Re: Sierra Club Comments on Puget Sound Energy's Draft Clean Energy Implementation Plan (Docket UE-210795)

Re: Sierra Club Comments on Puget Sound Energy's Draft Clean Energy Implementation Plan (Docket UE-210795)

# Report on the Puget Sound Energy 2021 IRP Plan

Figure 3: E3 Chart: Average Capacity Value of Wind in Northwest and MT/WY

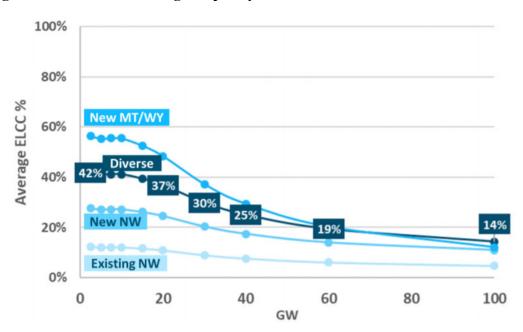
As shown in the chart provided below as Figure 3, modeling by industry consultant E3 shows significantly higher capacity values than PSE's assumptions. For example, E3 finds new Pacific Northwest wind offers capacity values above 25%, and that Montana or Wyoming wind provides 50-60% capacity value. Also noteworthy is that the average capacity value does not drop below 50% until nearly 20 GW of Montana and Wyoming wind is serving the region's utilities. Montana wind resources not only offer high capacity value, but a capacity value that

stays high at very high renewable penetrations. This will become increasingly important as PSE works to meet CETA targets.

Figure 4: E3 Chart: Coincidence of Wind Output with Load

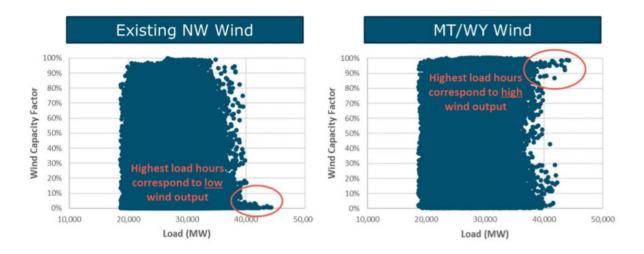
As discussed earlier in this section, Montana and Wyoming wind offers PSE capacity value that is high, and stays high. In the following chart, provided as Figure 4, E3 documents how that is driven by the correlation of those resources' output with PSE's peak loads, and the diversity complementarity with existing Northwest wind resources. As E3 explains, "[e]xisting wind in the Northwest today, primarily in the Columbia River Gorge, has a strong negative correlation with peak load events that are driven by low pressures and cold temperatures.

Conversely, Montana and Wyoming wind does not exhibit this same correlation and many of the highest load hours are positively correlated with high wind output."<sup>69</sup>

Figure 5: Complementary capacity value benefit between solar and storage

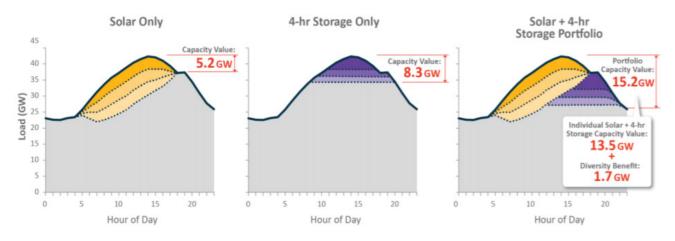
Adding battery storage helps keep the capacity value of wind and solar high, as battery storage can absorb wind and solar output when it is less valuable and shift it later in time to peak demand periods. <sup>74</sup> In particular, adding storage keeps solar capacity value high by making it possible to shift midday and early afternoon solar output to later in the afternoon and evening. Similarly, battery storage can shift overnight wind output later to help meet the morning load up ramp, particularly during winter periods when morning heating demand is high and solar output is low. Less intuitively, solar also boosts the capacity value of storage. Solar output in the late afternoon and early evening helps shift peak net load later into the evening. This also shortens the duration of the peak net load period, allowing limited duration storage resources to fully meet the peak demand. As shown in the chart from E3 provided below as Figure 5, the diversity benefit between solar and storage causes their combined Effective Load Carrying Capacity ("ELCC") to be greater than the sum of their parts. <sup>75</sup>
